**SUBJECT:** **Customer Satisfaction Program 21B04 – Supplement #1**  
 Certain 2017 through 2020 Model Year F550 Equipped with Payload Plus Upgrade Package  
 Frame Rail Crack

**New! REASON FOR THIS SUPPLEMENT**

- *Technical Instructions: Updated to clarify amount of use for Rotobroach cutter.*
- *Attachment V: Updated list of trucks that will not require bracket installation.*

FIGURE 7

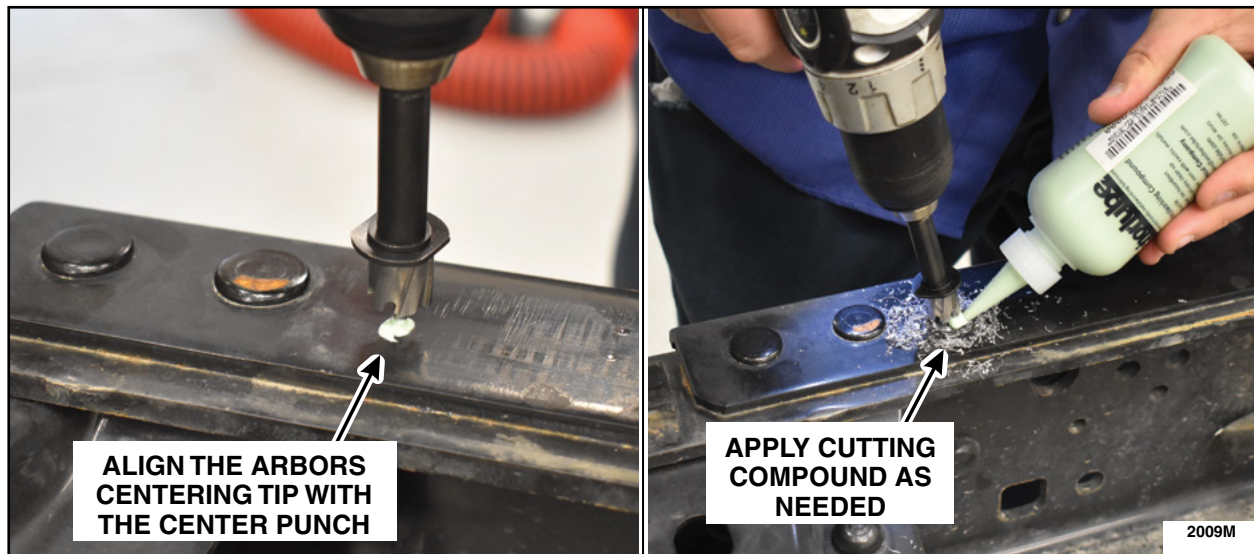
**NOTE:** Cutting fluid, such as Anchorlube G771 or equivalent, will need to be applied several times during the cutting out of these holes to prevent heat and aid in cutting. High heat will cause the bits to wear prematurely.

**NOTE:** On dual layer frame drilling, once the drill bit has cut through the upper layer you will need to stop and clear away any shavings and remove the loose piece of the upper frame in order to continue drilling through the lower layer. See Figures 7 and 8.

**NOTE:** One RotaBroach bit, with proper use of cutting fluid, will be able to drill holes on several trucks before needing replaced.

**FIGURE 14**

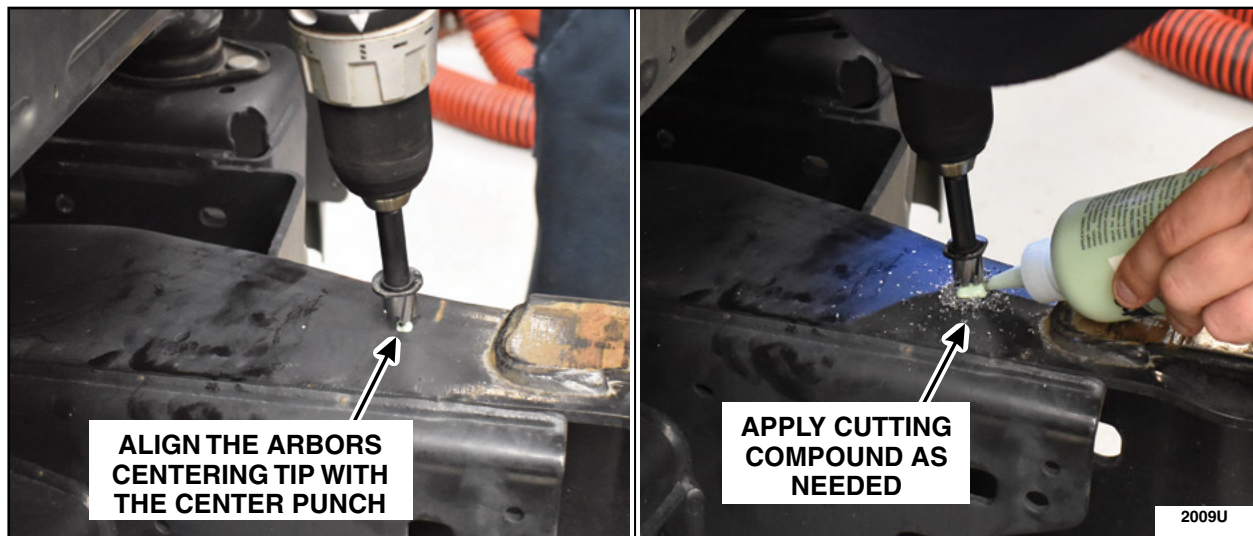
**NOTE:** Cutting fluid, such as Anchorlube G771, will need to be applied several times during the cutting out of these holes.

**NOTE:** One RotaBroach bit, with proper use of cutting fluid, will be able to drill holes on several trucks before needing replaced.
